# Access Compliance Report

### (Curb Ramps)

| Intersection ID: 23300                  | Main Street: SHARON_RD_WEST | Cross Street: SHARONBROOK_DR            | Location: S            |
| ADA ID: C8392F328B66                    | Ramp Type: Perp             | Initial Pass/Fail: Fail                 | Overall Compliance: No |

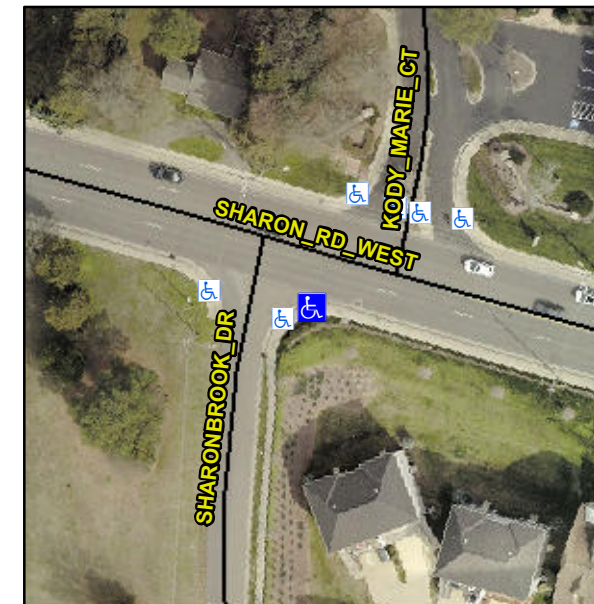
| Severity Score: 26.25                   |                             |   |                        |

**R304.2.2, R304.5.3**

| Compliance | Description           | Data | Compliance | Description                 | Data |
|------------|-----------------------|------|------------|-----------------------------|------|
| N/A        | Ramp Length (in)      | 66.0 | No         | Ramp Slope (%)              | 15.6 |
| Yes        | Ramp Width (in)       | 48.0 | No         | Ramp XSlope (%)             | 3.1  |

**Remove & Replace Entire Ramp.**

Total Cost: \$ 1850.00
